DRAINAGE STATEMENT

CEDAR END,
EASTERGATE LANE,
EASTERGATE

ARUN DISTRICT COUNCIL BN/82/24/DOC

Surface Water Drainage Comment Tracker

Drawing title
SITE PLAN SHOWING PROPOSED DRAINAGE LAYOUT.

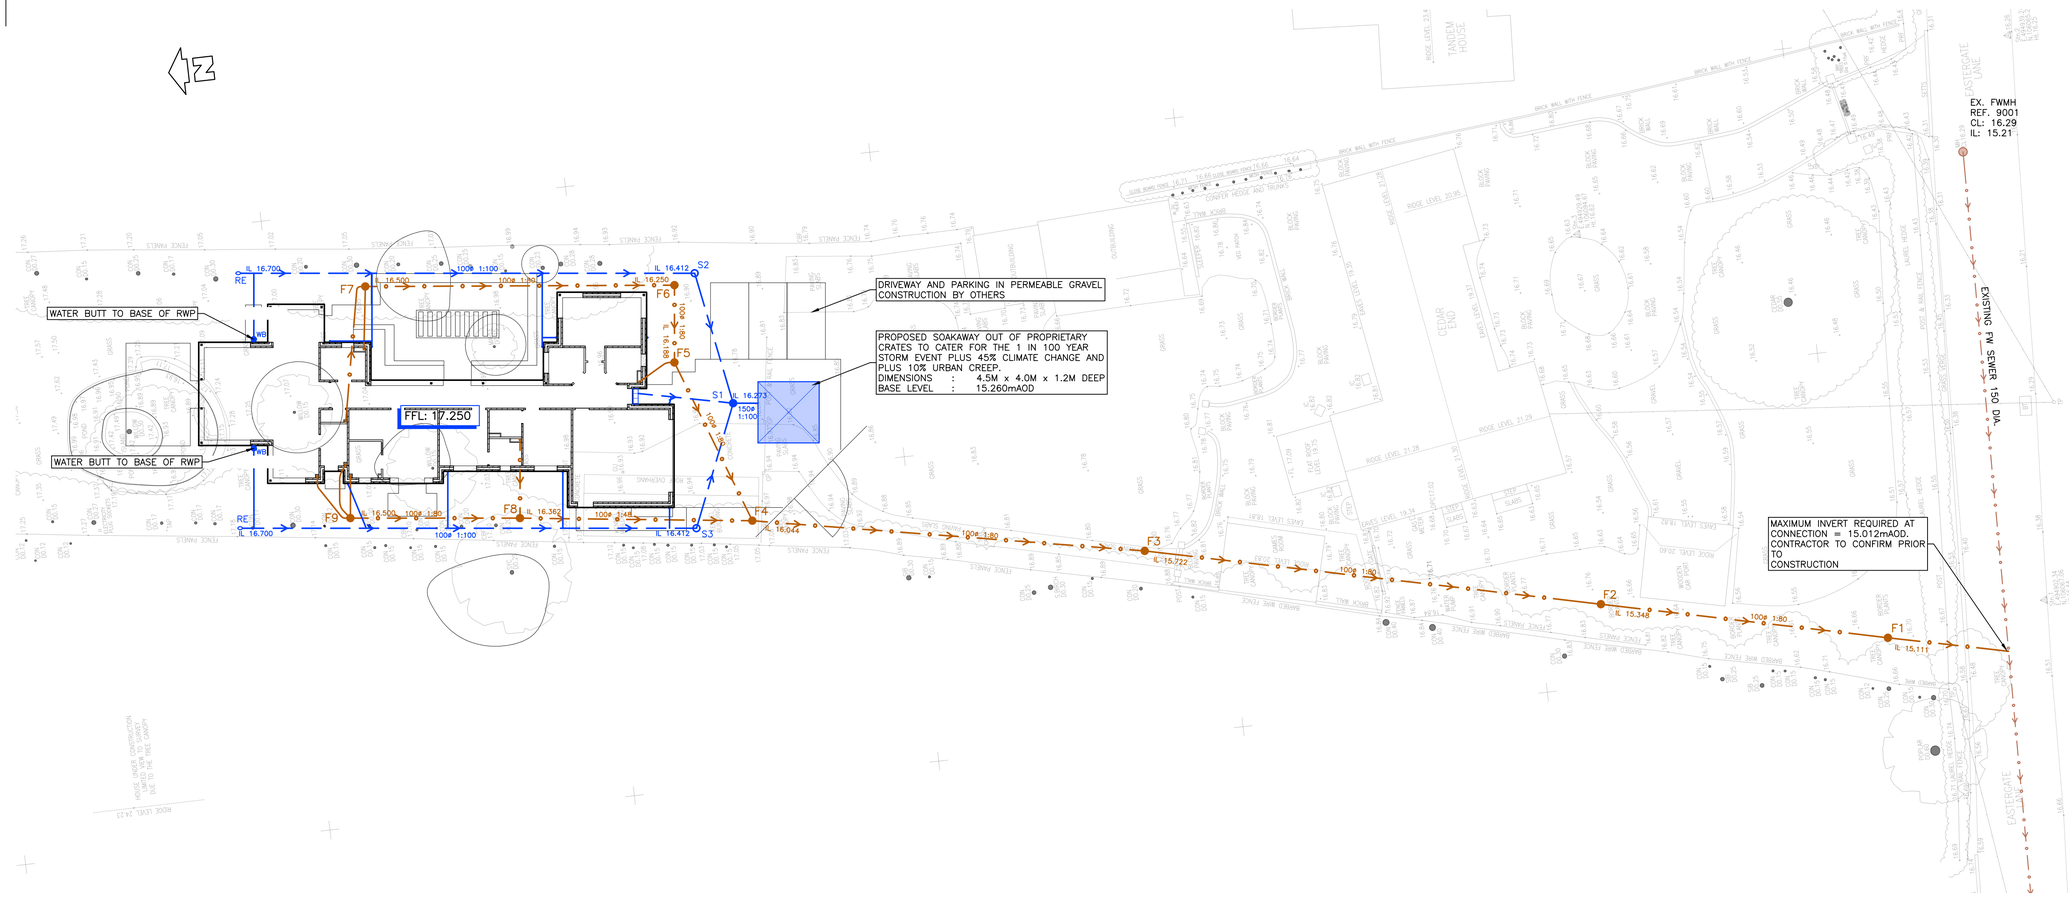
4.	Disposal method – Rainwater reuse should be maximised where possible in line with the SUDS hierarchy. Please adjust the design to introduce rainwater reuse where possible.	Water butt for re-use now added to the drawing.

7.	Please provide an assessment of water treatment for the updated design.	Assessment now included			
8.	A revised drainage layout must be provided which corresponds with the supporting calculations.	Provided

Rev.	Date	Description	By
P02	24.07.2024	RW BUTTS & MINOR IL REVISIONS	CH
P01	18.06.2024	PRELIMINARY ISSUE	CH

Drawing title
DRAINAGE DETAILS.

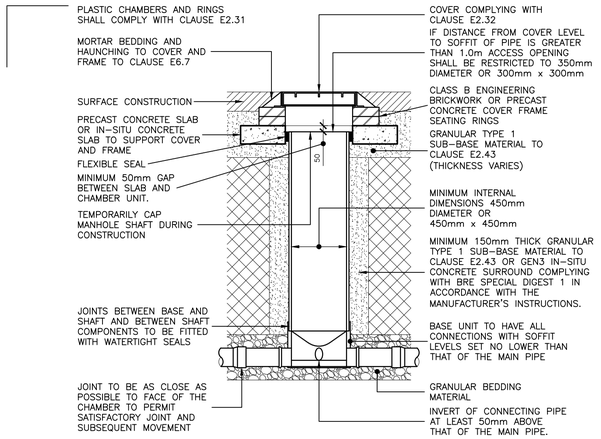
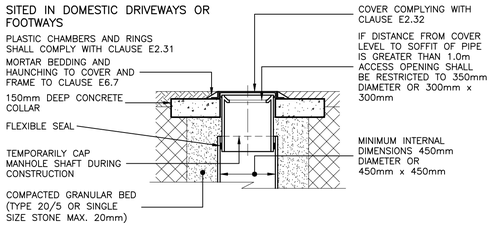
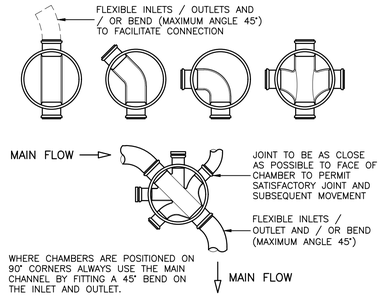
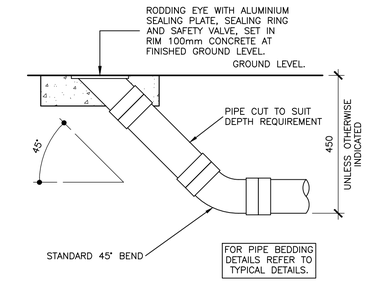
9.	Construction detail drawings for all drainage components must be provided for the updated design.	Provided			
10.	Please confirm that no existing or proposed trees are near the proposed soakaway or pipes. Please indicate any areas that may need tree root protection on the layout as appropriate.	We confirm that there are no existing or proposed trees that will impact on the the drainage
